**Application for Minor Amendments
to the Building B5 Reserved Matters
Approval 2014/6968/P**

King's Cross Central General Partner Ltd

September 2015

client	King's Cross Central General Partnership
project	Building B5
drawing title	Proposed GA First Floor Plan
drawing no	EPA KXC 05 116
scale	1 : 250 @ A3
revision	P1

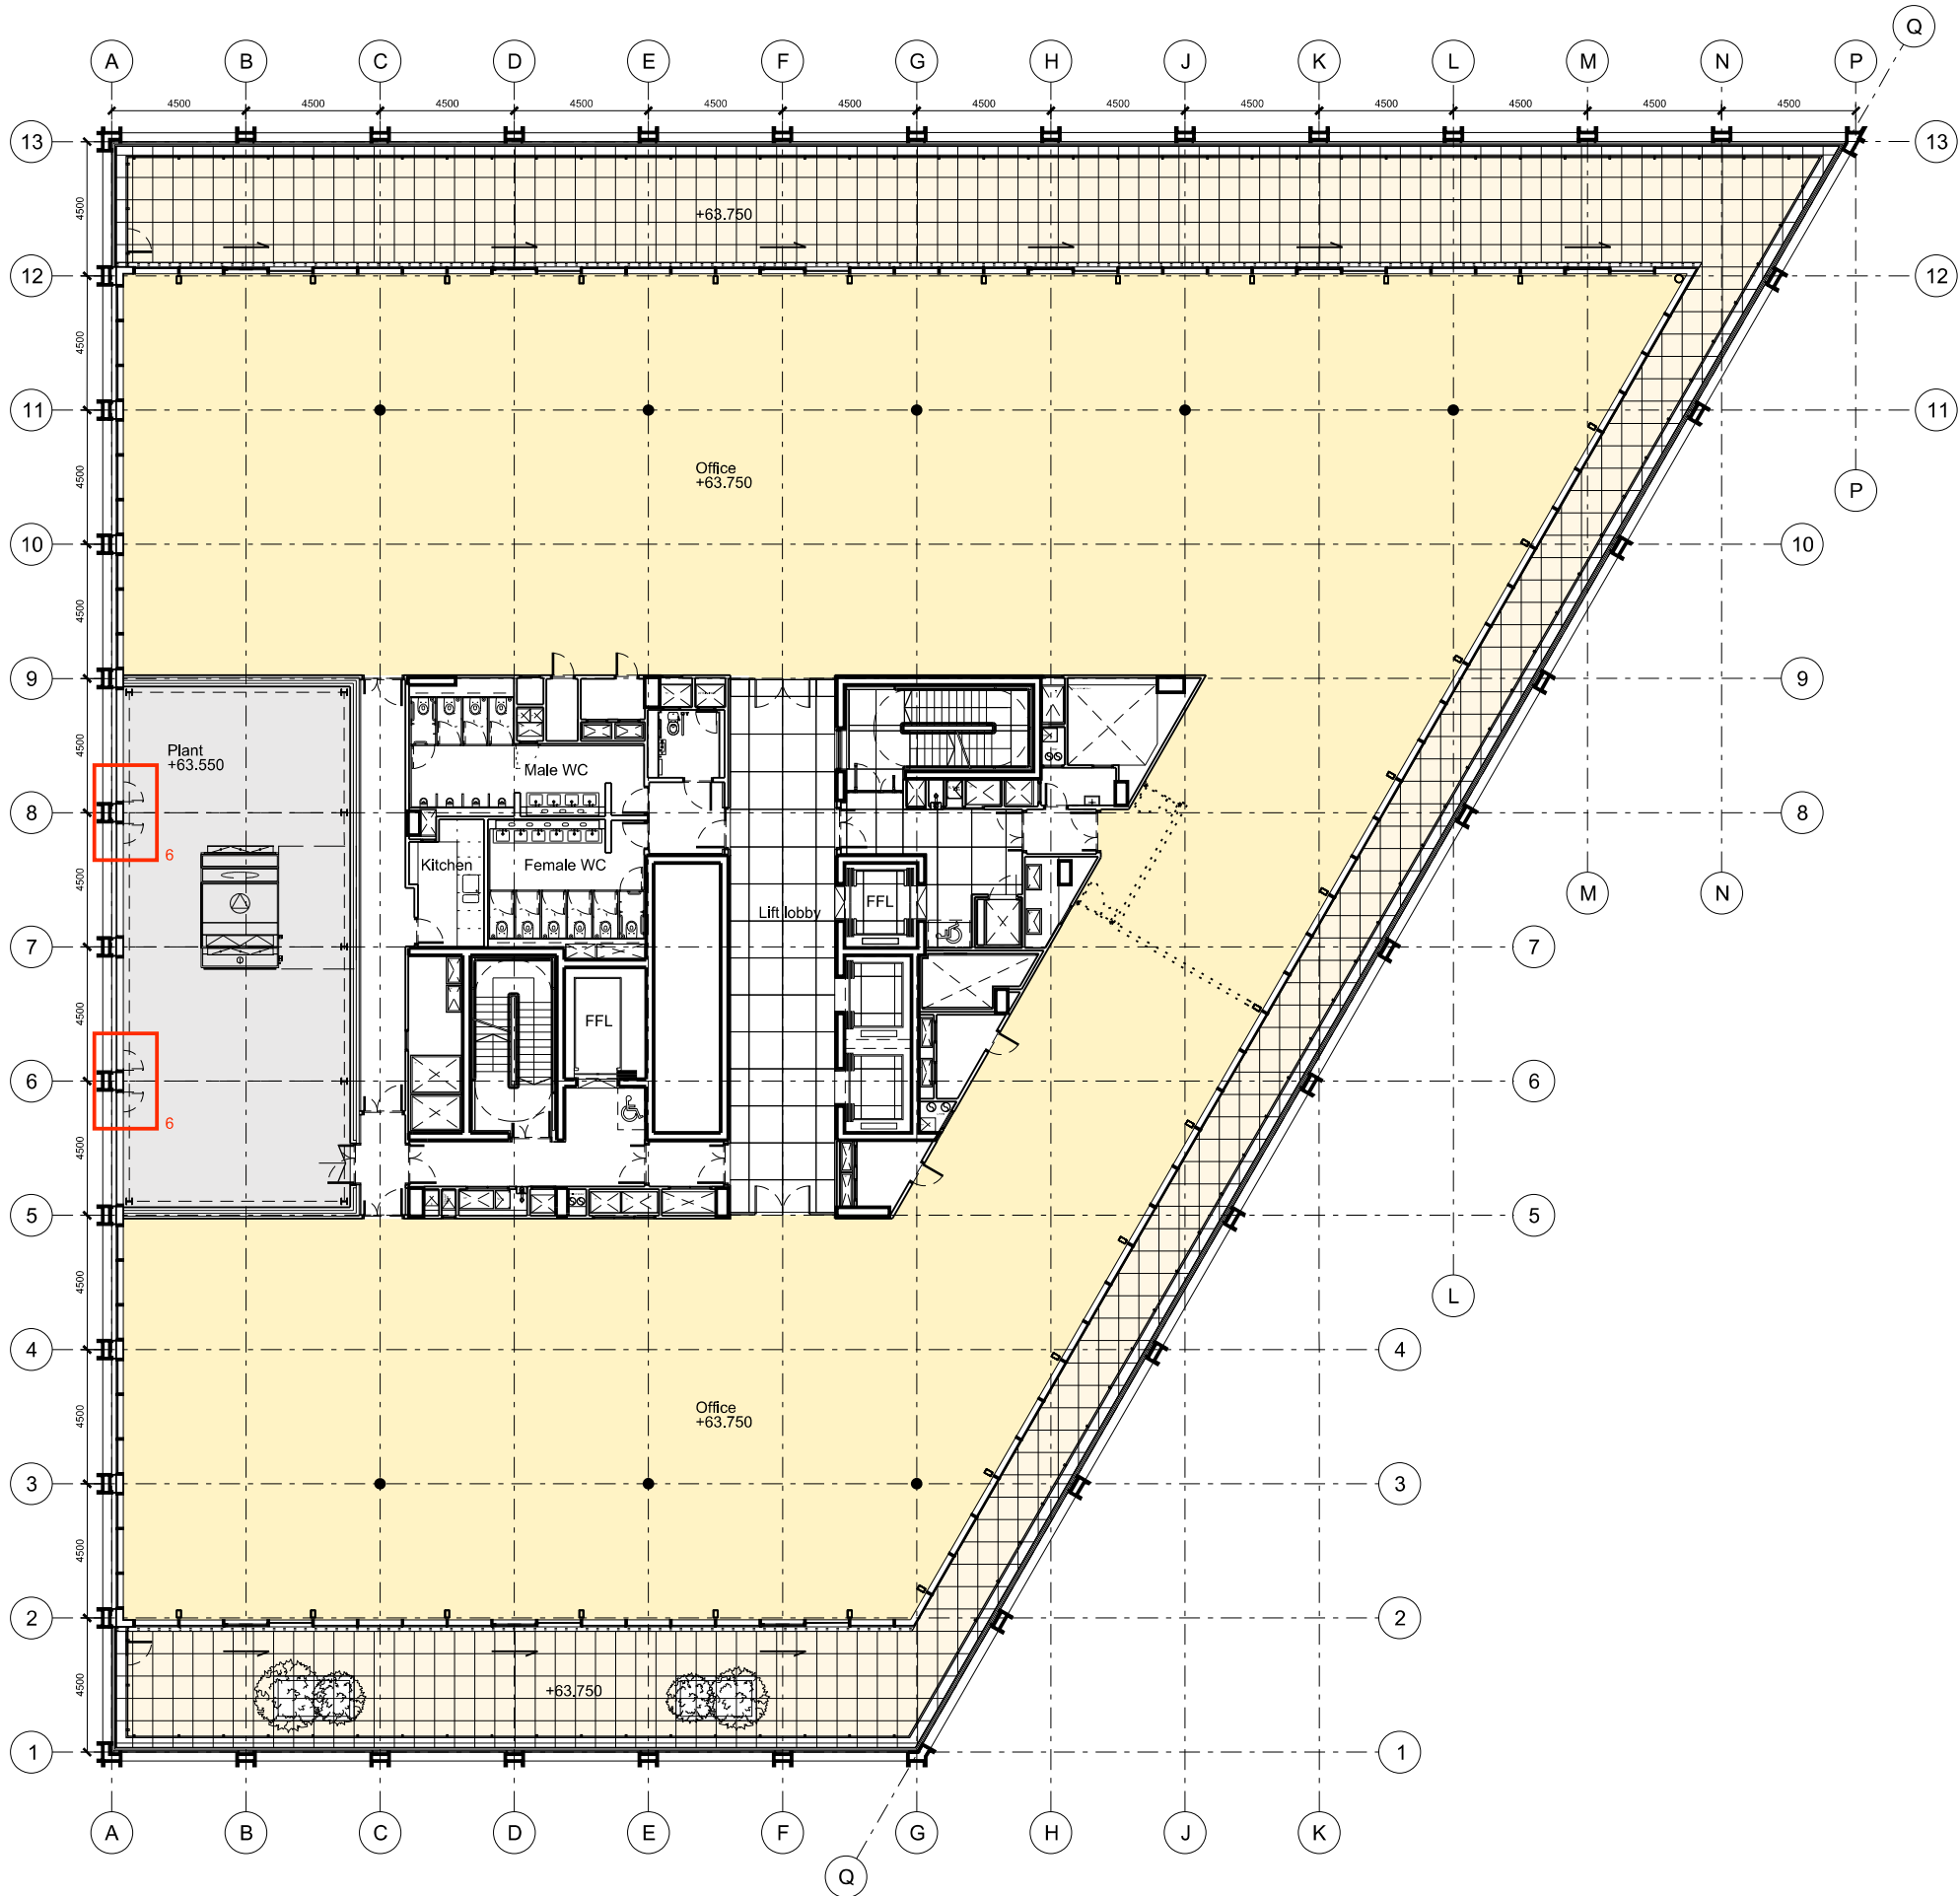
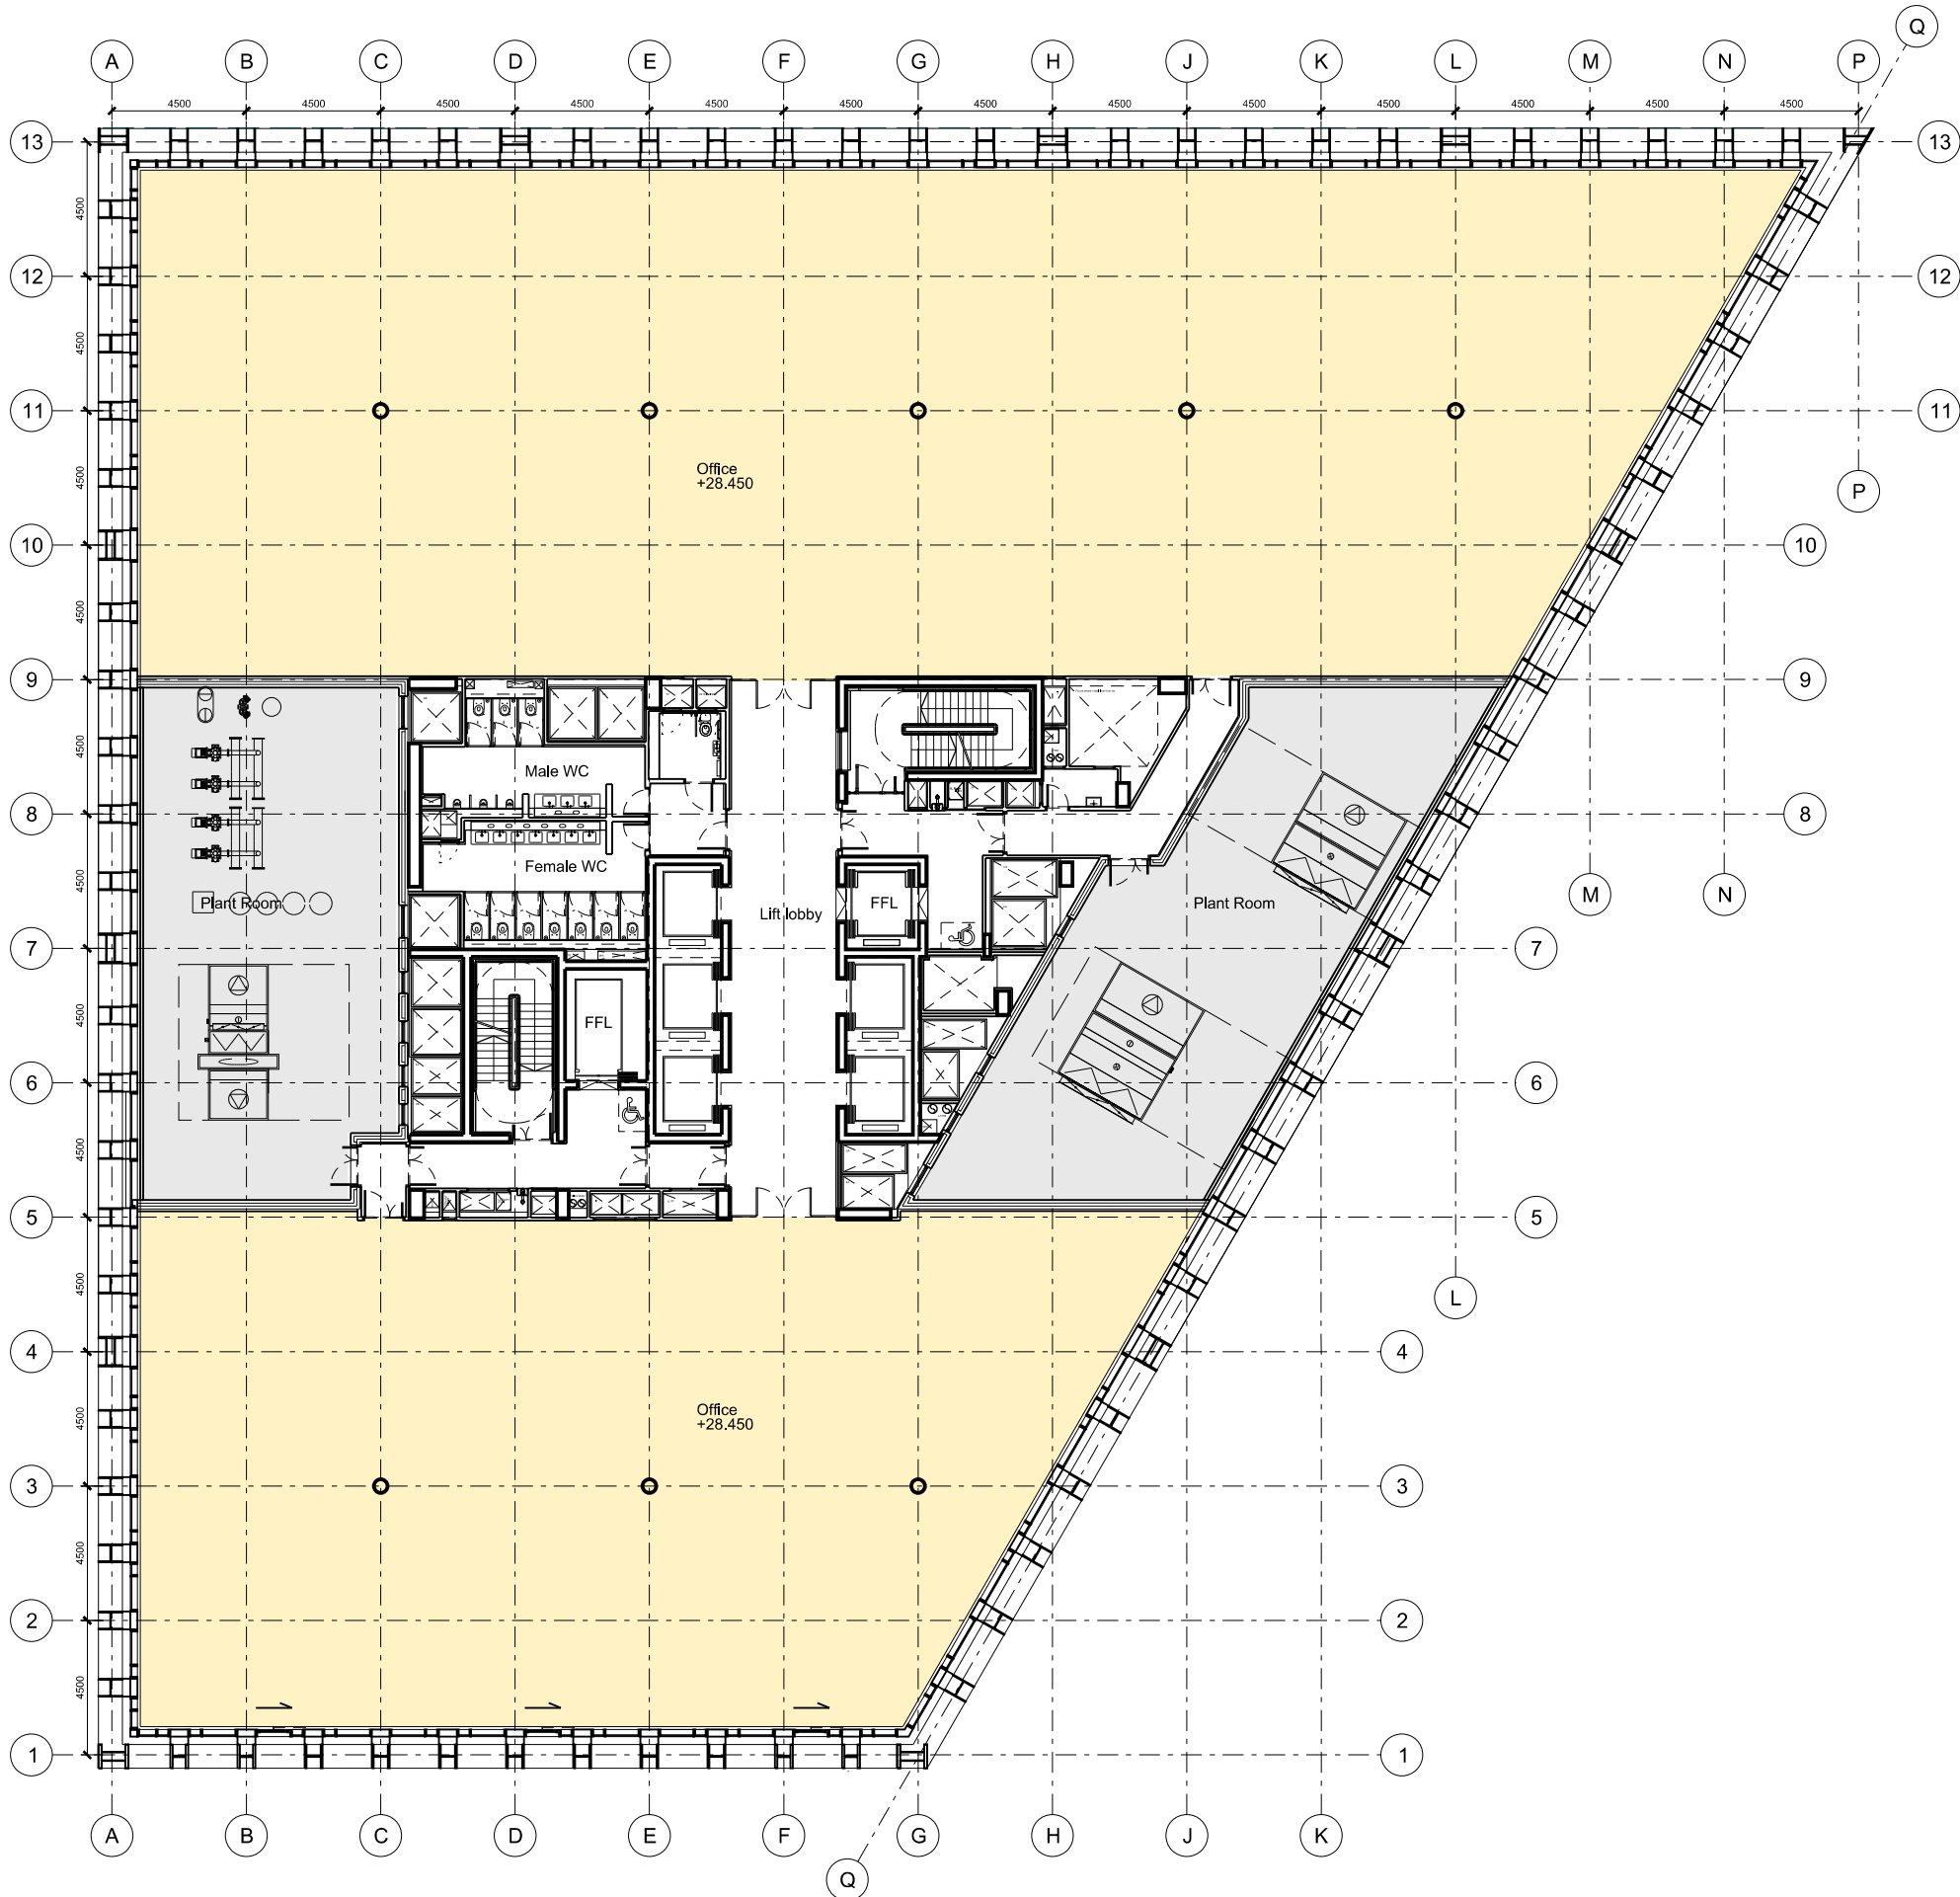
5. First floor plant rooms removed to release office floorspace; plant louvres replaced with glazing.

Rev	Description	Date	By	Chk
P3	Tone added.	27.05.15	MM	RD
P2	Plant rooms reduced in size.	16.02.15	MM	RD
P1	Sliding doors amended.	16.12.14	RD	RK
P0	Planning Submission.	29.09.14	JT	RD
